WORK INSPECTION REQUEST (WIR) FORM

Contractor:	HAIF-FREYSSINET JV
Project:	RA2RC
Contract No.:	QPMO-410-CT-00618
Work Inspection Request Number:	QRXM114000-HFC-TEC-WIR-ITS-02-RO5-00070

Inspection request for Installing of ITS Cabinet 9 Nos, at Interim Road (Upgrade) and Junction 01 & 02 & 03 area.Size, (H1800 x SW800 x XD600),MMIP65,GIG90 Sheet),at Access to Resort core interim Road Mainline-02.As per Attached Drawing

Drawing title:
ITS SHOP DRAWINGS (UPGRADE)
ITS COMMUNICATION CABINET

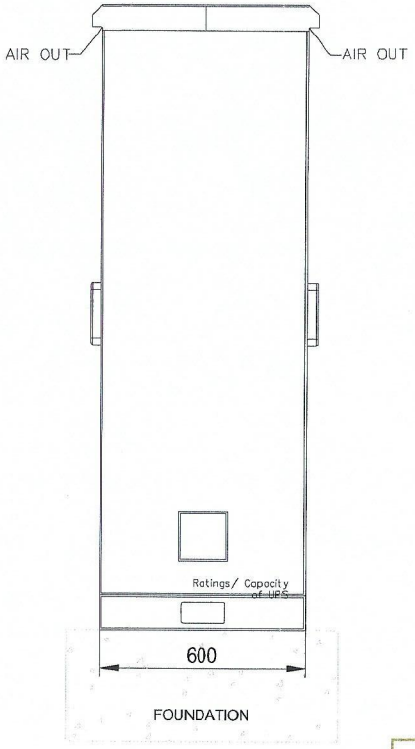
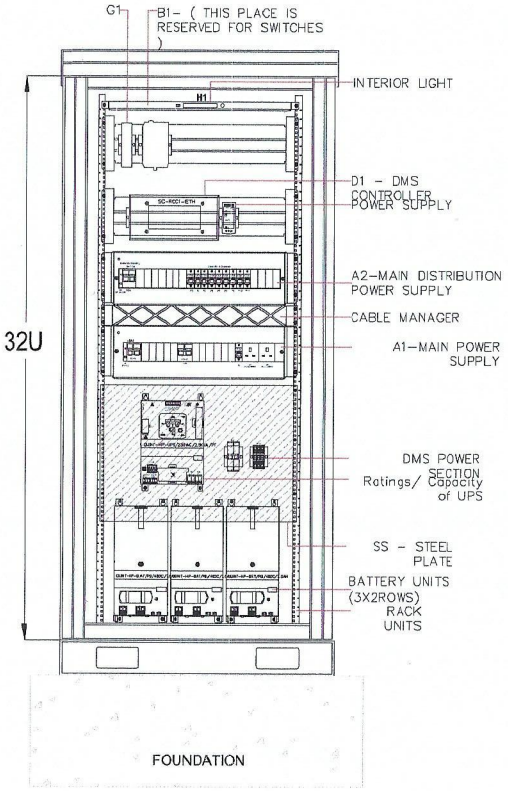
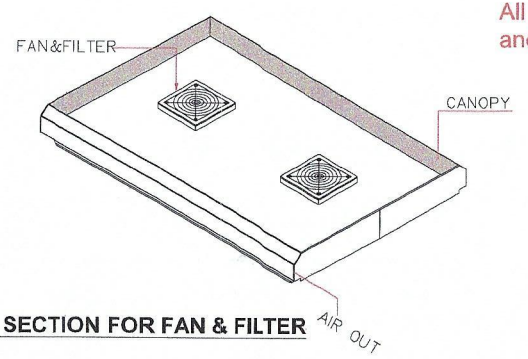
Reference shall be provided for 2300VA load
